MAPA Meeting - August 9, 2022

Recent and Upcoming Policy Changes (effective October 1, 2022 unless otherwise noted)

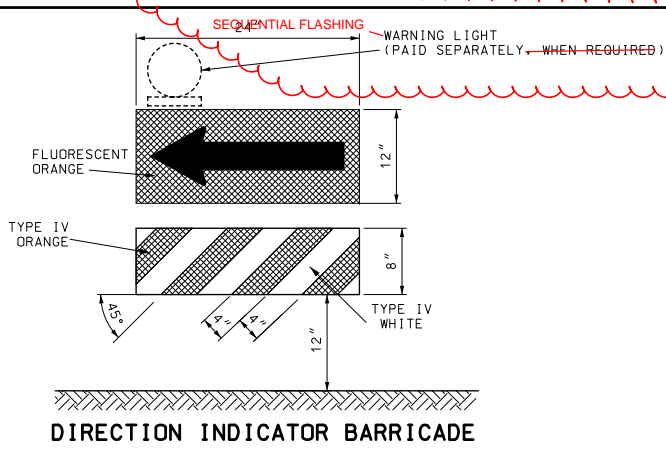
3. This revision to Sec. 109.15.1 reaffirms the intent of the specification to keep AC adjustments in sync with payments estimates.

109.15.1 Asphalt Cement Price Index. Adjustments will be made to the payments due the Contractor for any plant mix bituminous base, plant mix bituminous pavement, plant mix bituminous surface leveling, asphaltic concrete pavement and ultrathin bonded asphalt wearing surface that contains performance graded (PG) asphalt binder when it has been determined that the Monthly Asphalt Index for the month prior to placement of the asphalt mixture has fluctuated from the Monthly Asphalt Index for the month the project was let. The Monthly Asphalt Index shall be established for each calendar month as the average of the midpoint selling prices of PG64-22 for St. Louis and Kansas City, Missouri areas, as published by Poten and Partners Inc. in the Asphalt Weekly Monitor®, on the first Monday preceding the date of the normal monthly MoDOT letting. For months when there is no normal monthly letting, the published price on the third Monday of that month shall be used for the Monthly Asphalt Index. Special lettings shall have no effect on determining the Monthly Asphalt Index. The asphalt base index shall be the Monthly Asphalt Index for the month of the bid opening. For calculation of the price adjustment, any asphalt placed on the first day of a month will **generally be considered as be included with the asphalt** placed the previous month **in order** to keep price adjustments in sync with **the MoDOT's normal** payment estimate period schedule. **The Commission reserves the right to include asphalt placed on the first day of the month with the current month to accommodate financial accounting termini, such as the beginning of state and federal fiscal years (July 1 and October 1).**

MISSOURI HIGHWAYS AND TRANSPORTATION COMMISSION	
	105 WEST CAPITOL JEFFERSON CITY, MO 65102 1-888-ASK-MODOT (1-888-275-6636)	
	TEMPORARY TRAFFIC CONTROL DEVICES CHANNELIZERS AND DIRECTION INDICATOR BARRICADE	
	DATE EFFECTIVE: 10/01/2021 DATE PREPARED: 7/13/2021	616.10AY AZ

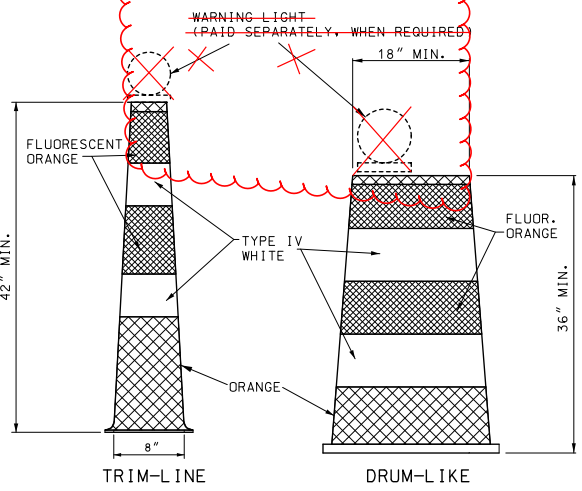
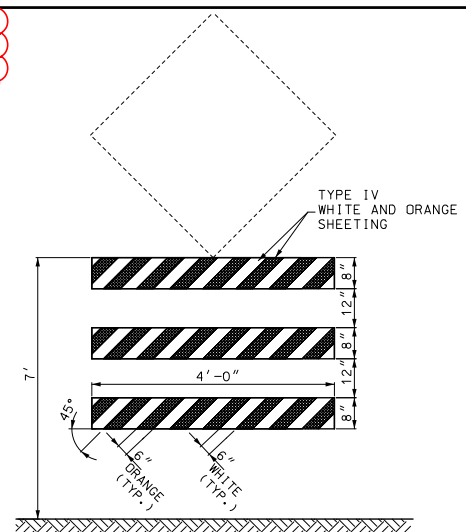
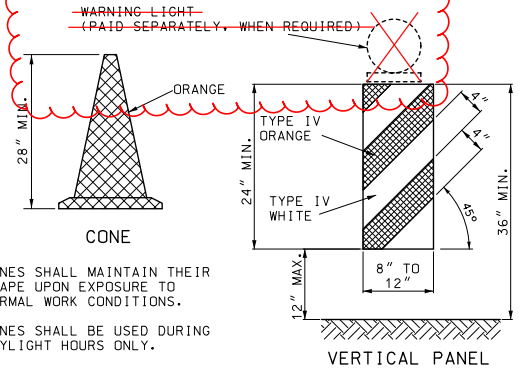
1. EPG 616, Sec. 616.5, Sec. 1063, and Std. Plan 616.10 have all been updated to remove Temporary Warning Lights from work zone devices. An example of the standard plan is at the end of this document.

- ~~IF USED, THE WARNING LIGHT UNIT AND BATTERY COMPARTMENT SHALL BE FURNISHED BY THE DEVICE MANUFACTURER OR OTHERWISE MEET THE MANUFACTURER'S RECOMMENDATIONS FOR DESIGN AND WILL BE REQUIRED ON ALL DEVICES IN THE SERIES.~~

- ~~WARNING LIGHTS SHALL BE IN ACCORDANCE WITH SEC 1063.5.~~
- UPON APPROVAL OF THE ENGINEER, THE CONTRACTOR MAY, AT NO ADDITIONAL COST, USE DRUM-LIKE CHANNELIZERS IN LIEU OF TRIM-LINE CHANNELIZERS TO PROVIDE LONGITUDINAL CHANNELIZATION WITHIN THE ACTIVITY AREA WHERE NO RAMPS, INTERSECTIONS OR LIMITED LATERAL CLEARANCE EXISTS.
